April 30, 2008

Re: Draft North Coast Instream Flow Policy

**A Critical Review of the December 2007 State Water
Resources Control Board Draft Policy for Maintaining
Instream Flows in Northern California Coastal Streams and
Supporting Documents**

FIGURE 5-1
Drainage area of onstream storage rights of record in Maacama Creek watershed

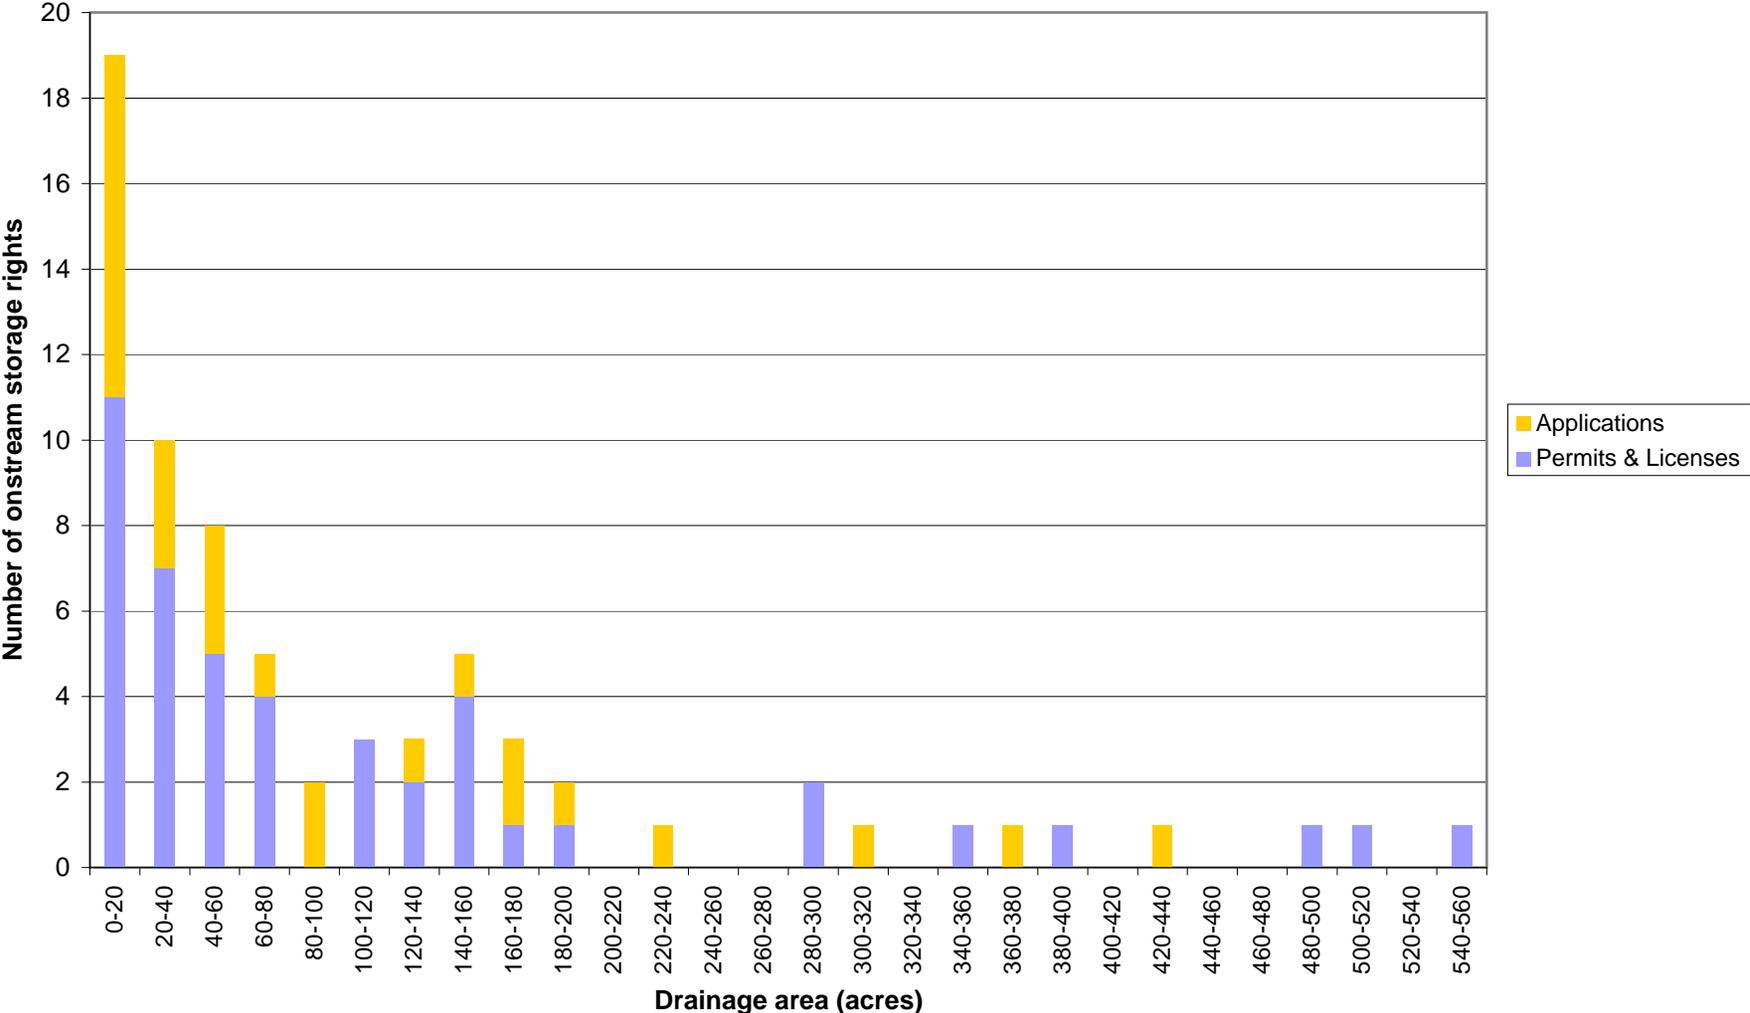
Figure 5-1 (attached) summarizes the drainage areas associated with onstream reservoirs as identified in the State Water Board eWRIMS database in the Maacama Creek drainage. The total number of onstream reservoirs, including pending and permitted/licensed, is 71. The median drainage area size is 53 acres (less than 0.1 sq. mi.). Ninety percent of the drainage areas are less than 320 acres (0.5 sq. mi.). All are less than 550 acres.

FIGURE 5-2
Drainage areas of existing and proposed onstream reservoirs named in pending applications represented by WBE and within draft Policy area

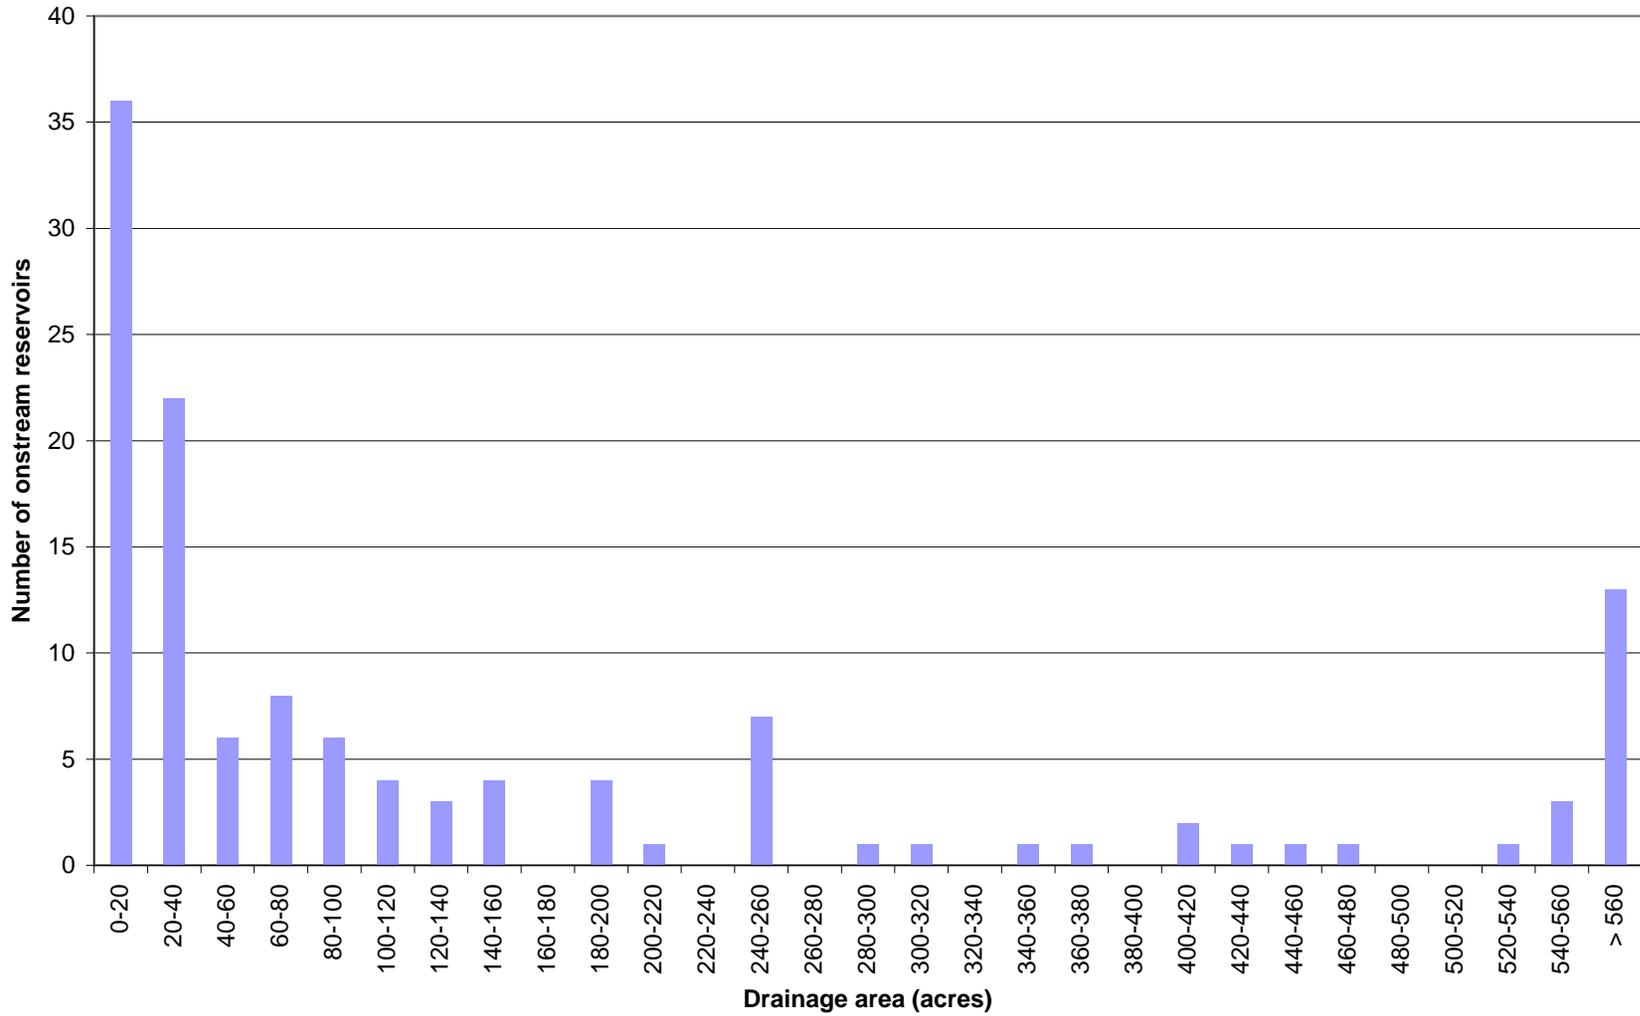
Figure 5-2 (attached) summarizes the drainage areas associated with all existing and proposed onstream reservoirs named in pending applications represented by Wagner & Bonsignore Engineers in the Policy area. The total number of onstream reservoirs in this sample is 124. This chart looks similar to the Maacama Creek basin chart. The major difference between the two samples is the large drainage areas associated with a few Wagner & Bonsignore Engineers client projects. Seven of the drainage areas larger than 560 acres are overlapping as they represent a string of seven reservoirs located along Arroyo San Jose Creek in Marin County within a golf course. If the six redundant drainage areas inside of the largest drainage area on the golf course are excluded, the median drainage area of this sample is only 40 acres. Ninety percent of the drainage areas in this study are smaller than 420 acres.

FIGURE 6-1
Recapitulation of Scientific Basis Figure E-4 using linear axes
(showing drainage areas less than 200 sq mi and Qopt / Qm less than 500%)

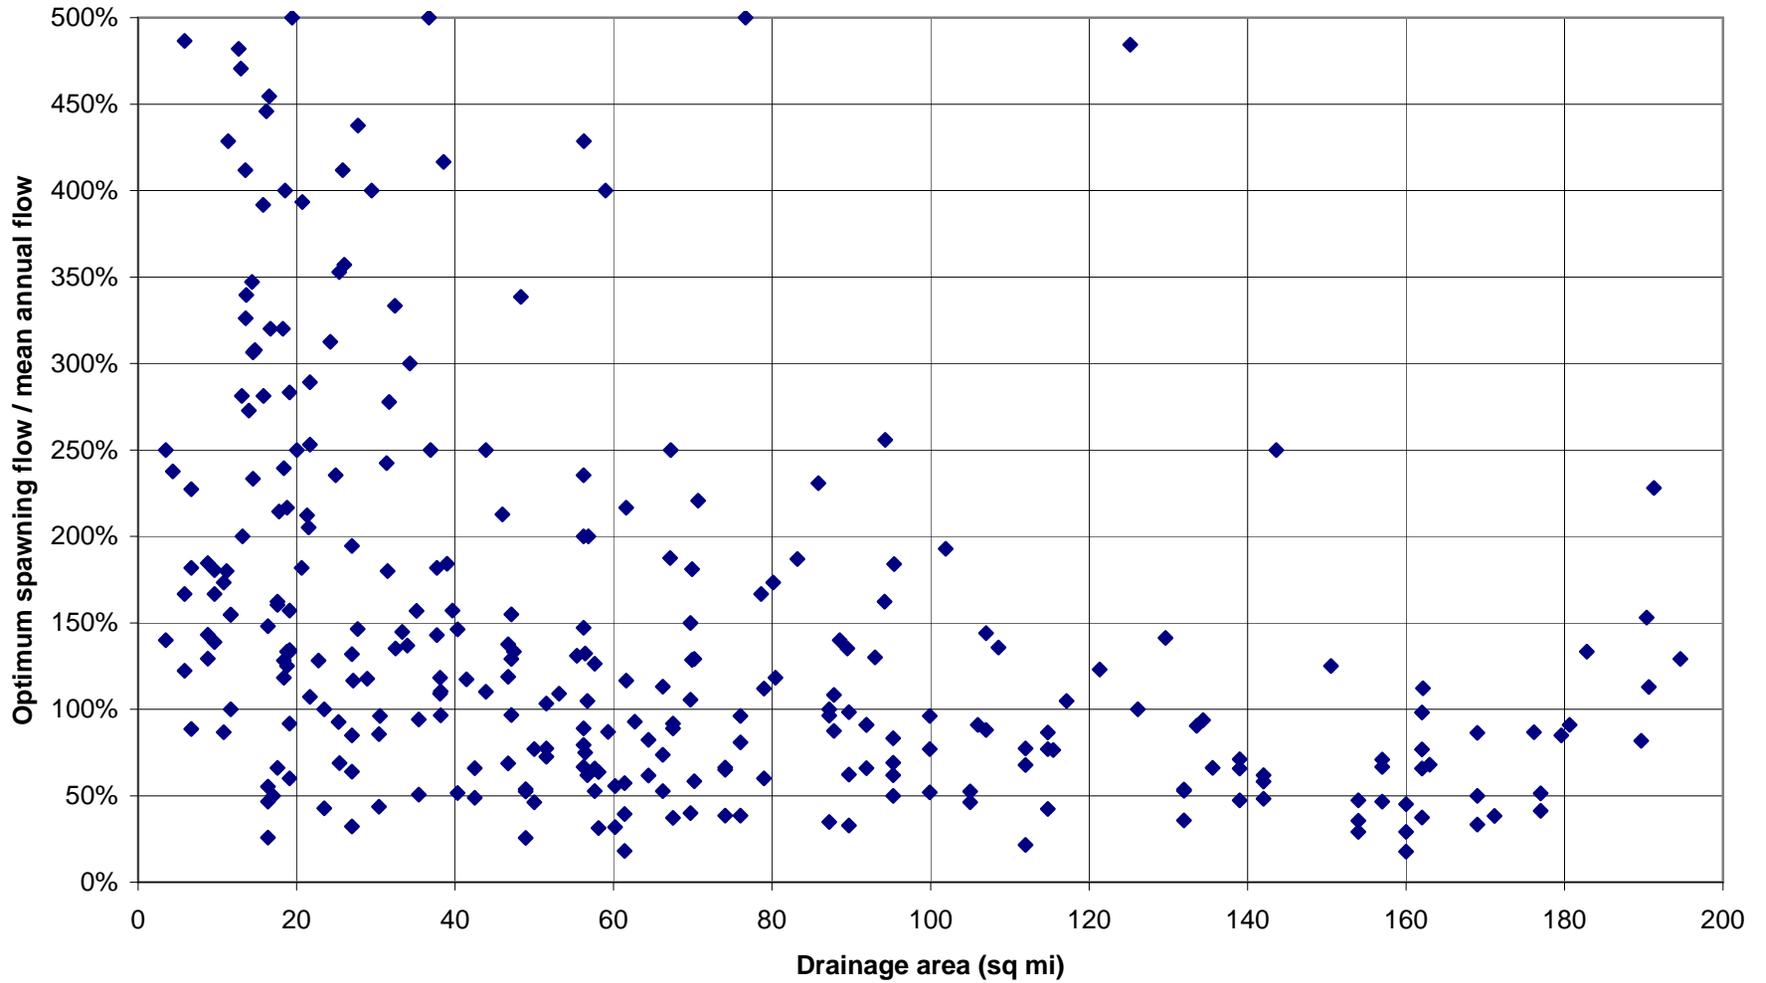
Perhaps because of the expense involved in estimating the optimum flow for anadromous salmonids, the Scientific Basis next attempted to find a way to predict optimum flow throughout the North Coast region from a readily available parameter. The choice of parameter was drainage area. Figure E-4 (p E-11) summarizes recommended minimum instream flows.¹⁴ The recommended flow for spawning was divided by the mean annual flow for plotting on the vertical axis. Drainage area is on the horizontal axis. Note that both axes are logarithmic. Drainage areas range from 3.48 sq. mi. to 6,248 sq. mi. The median is 74 sq. mi. This is far larger than the drainage areas associated with most pending applications for storage in the Policy area.

This plot shows a general trend of greater recommended flow to mean annual flow for smaller drainage areas. But this plot clearly shows that drainage area is insufficient to estimate recommended flow. At any given drainage area, the corresponding recommended flows range widely. For instance, at 70 - 80 sq. mi., the recommended flow ranges from 0.4 or 40 percent of mean annual flow to 5.0 or 500 percent of mean annual flow. It is also instructive to view this same data with linear axes as shown in Figure 6-1 (attached). No manner of statistical analysis is going to make drainage area a good predictor of recommended flow, as shown in Figure E-4.

FIGURE 8-1
Project #15: Modeled impairment at POD#1 with no diversion constraints
Normal water year

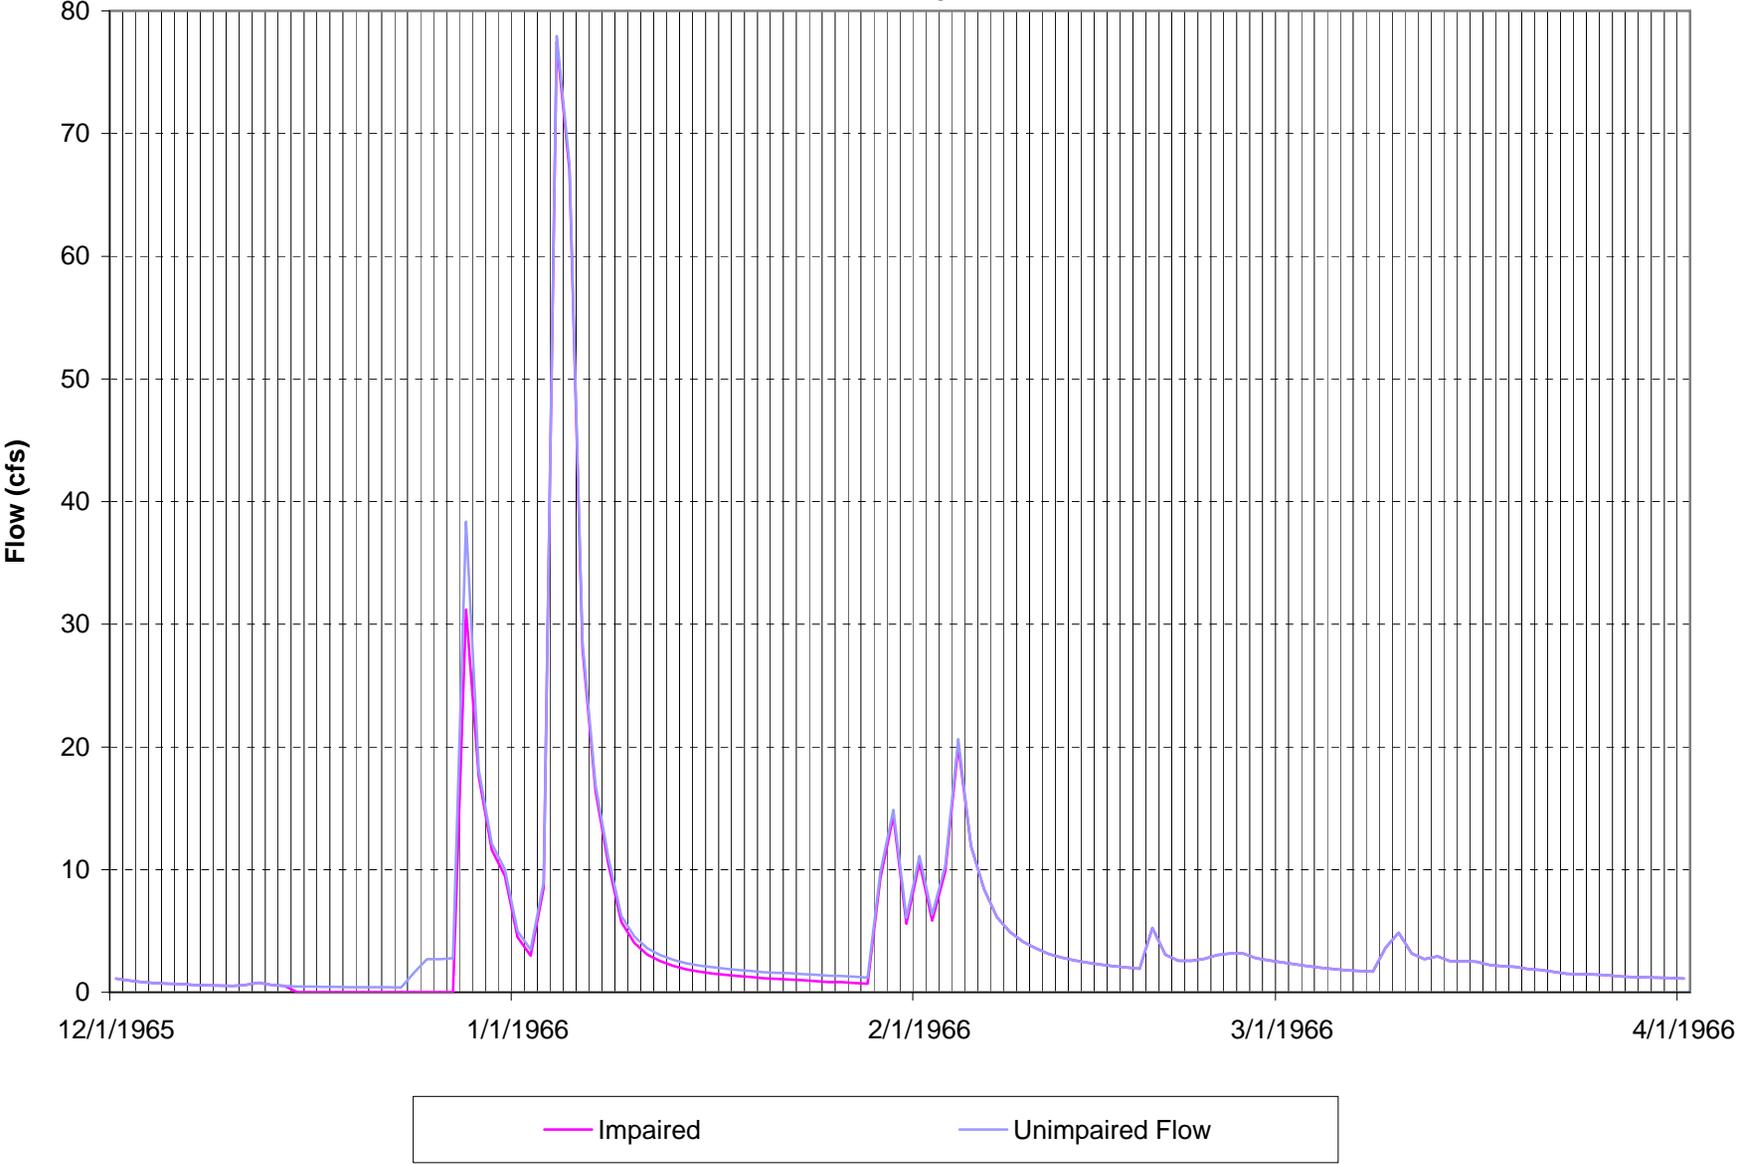
Figure 8-1 (attached) shows modeled impairment during a normal hydrological year immediately below POD #1 assuming no constraints on diversion. It can be seen that the

FIGURE 8-2
Project #15: Modeled impairment at POD #1 under Policy
Normal water year

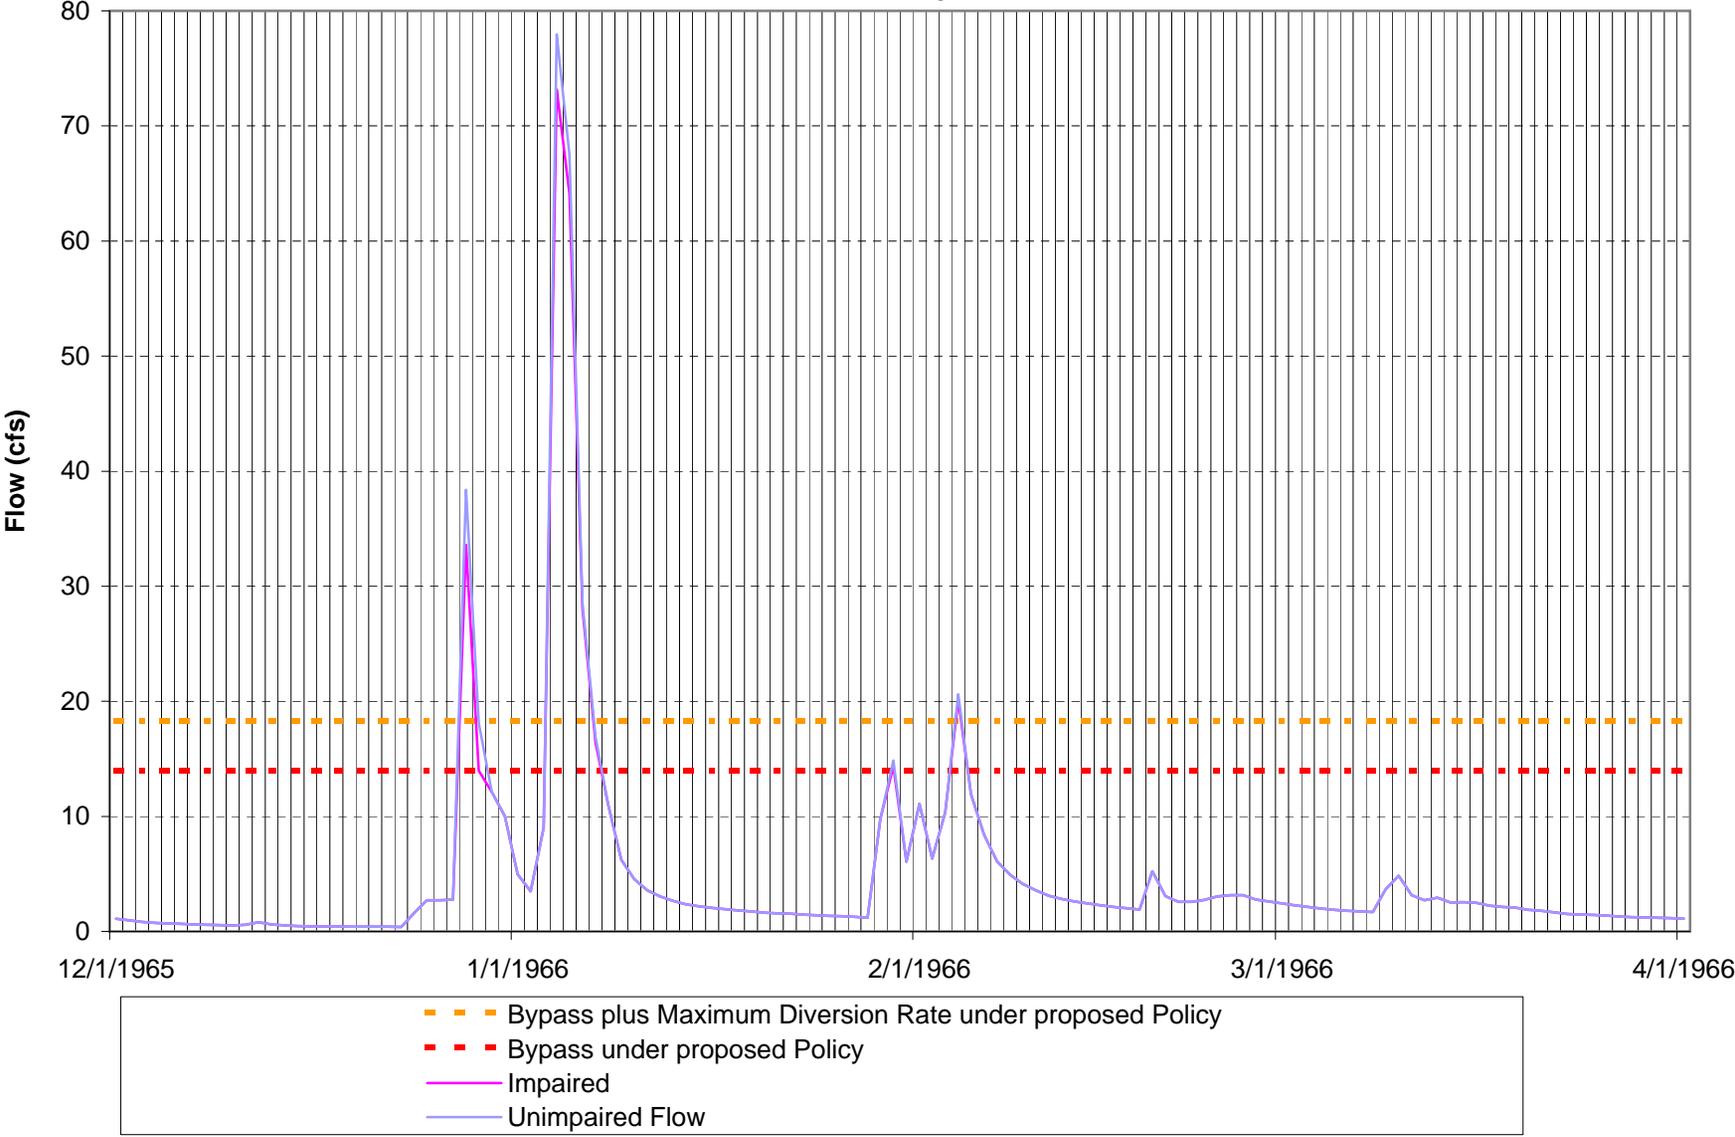
Figure 8-2 (attached) shows the modeled impairment at the same location during the same year, but this time subject to the Draft Policy diversion constraints. Also shown in Figure 8-2 is the bypass requirement and maximum diversion rate associated with the Draft Policy. Only that part of the hydrograph above the red line and below the orange line is available for diversion under the Policy.¹⁷ The average annual project yield under the Policy would be 36 AF, i.e., less than half the yield without diversion constraint.
